**NUMBER:** 23-014-13 REV. A

Sunroof Opens But Will Not Close And/Or Cycles Back To Open And/Or Sunroof Glass Scratched

This bulletin involves inspecting sunroof glass clearance and if necessary, modifying the sunroof reinforcement to allow adequate clearance for sunroof glass travel.

2012- 2013 (RT) Caravan/Town and Country

**Fig. 1 Apply Tape**

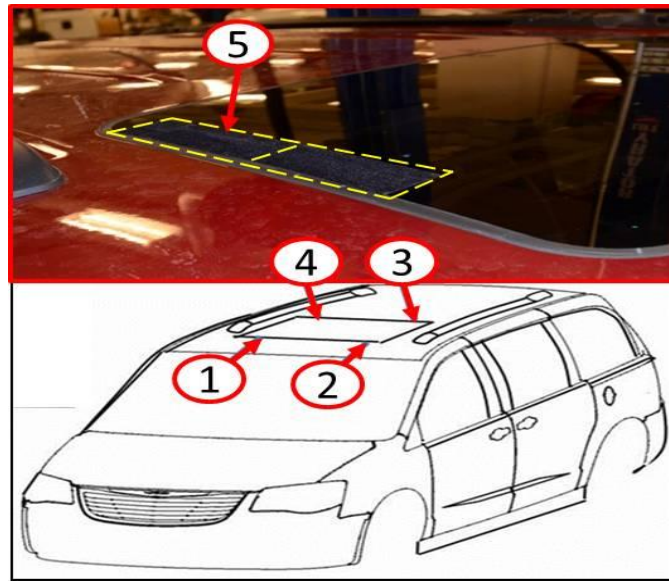
1. Adjust sunroof panel flushness along the front of the glass (1)&(2) to 2mm underflush. Adjust the rear of the sunroof glass panel (3)&(4) to zero/flush ([Fig. 1](#)).

2. Apply two pieces of felt/flock tape p/n 05019055AA to each side of the sunroof glass panel. Apply the tape end to end along the side edge of the sunroof glass panel (5) starting at the end of the rear corner radius running forward ([Fig. 1](#)).

**NOTE: Once the proper glass position has been achieved, tighten the six glass panel attaching screws to 3.5 Nm (31 in. lbs.).**

**Fig. 2 Inspect**

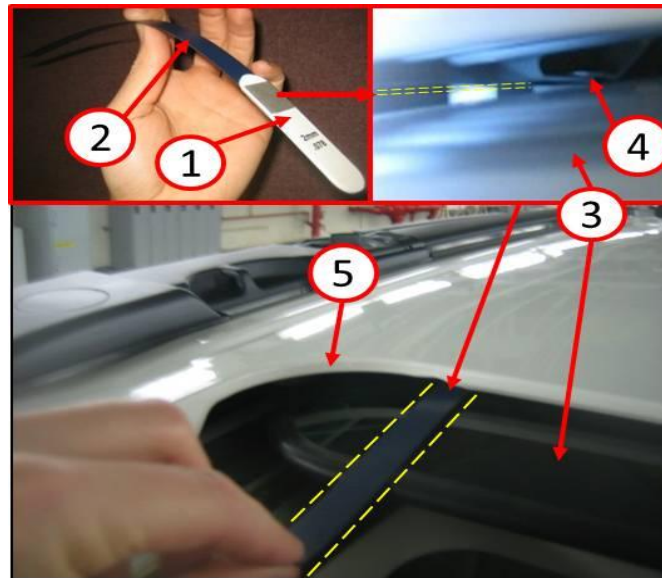
Cycle the sunroof panel to the full open position and use a 2mm feeler gage (1) to check left and right sunroof glass (3) to inner sheet metal reinforcement (4) gap. Use a flashlight to locate the lowest point between the sheet metal reinforcement (4) and sunroof glass (3) (Fig. 2).

- 
3. Is the clearance between the inner sunroof sheet metal reinforcement and sunroof glass 2mm or greater?
    - a. Yes>>> This bulletin does not apply, further diagnosis required.
    - b. No>>> Cycle the sunroof to the fully closed position and remove the felt/flock tape. Proceed to [Step #4](#).
  4. Remove the sunroof module. Refer to the detailed procedures available in DealerConnect> TechCONNECT under: Service info> 23-Body> Sunroof> SUNROOF> Removal.

**Fig. 3 Modify Using Special Tool**

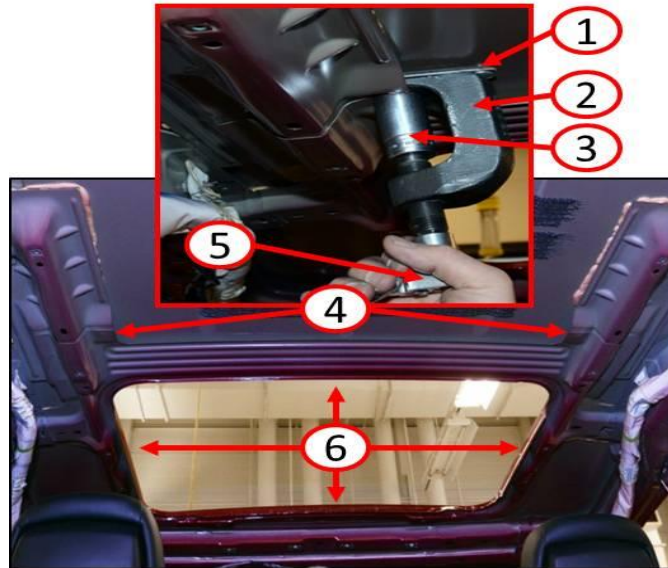
5. Using a backer plate (1) or heavy (3/8"/10mm minimum thickness) cardboard to protect and disburse any pressure applied against the outer roof sheet metal, insert the C-4150A ball joint press/special tool (2) into the low hanging sunroof reinforcement feature (4) (Fig. 3).
6. Insert a 30mm socket or equivalent (3) between the sunroof reinforcement and spindle of the C-4150A ball joint press/special tool to take up space between the frame and spindle of the press. Carefully tighten the spindle of the press to compress the center of the sunroof reinforcement upward (Fig. 3).

**Fig. 4 Verify Modification**

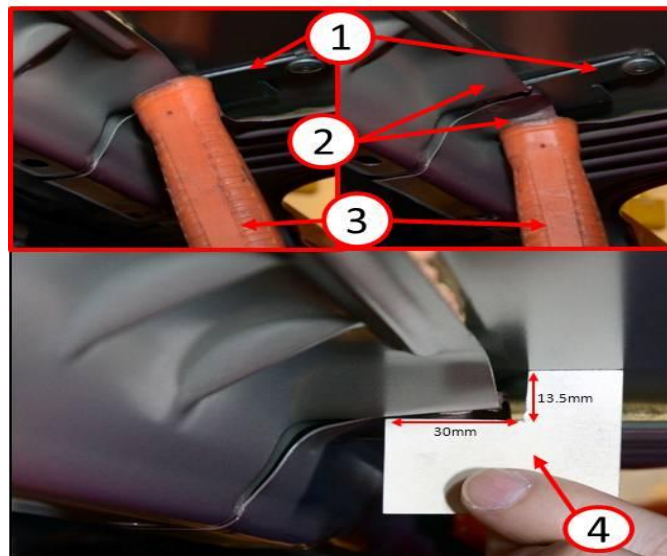
7. Using a backer plate (1) or heavy (3/8"/10mm minimum thickness) cardboard to protect and disburse any pressure applied against the outer roof sheet metal, carefully push the remaining left and right side of the low hanging sunroof reinforcement feature (2) upward using a hammer handle or equivalent blunt tool (3) to provide additional clearance (Fig. 4).

**WARNING:**A backer plate must be used to protect the exterior roof sheet metal panel from deformation and evenly disburse any pressure placed on the exterior roof panel. Failure to do so will result in damage to the outer roof panel as the raised center of the reinforcement will contact the outer panel creating a dimple or dent from focused pressure at the point of contact.

8. Using an index card or folder stock, create a verification gage (4) that will ensure the proper clearance is achieved as a result of modifying the sunroof reinforcement. The gage should measure 13.5mm down from the outer roof panel and 30mm inward from the outer edge of the sunroof reinforcement. Move the verification gage back and forth along this area to ensure proper clearance is achieved (Fig. 4).

**NOTE:** Repeat the modification procedure for the opposite side of the vehicle or on existing side until desired clearance is achieved.
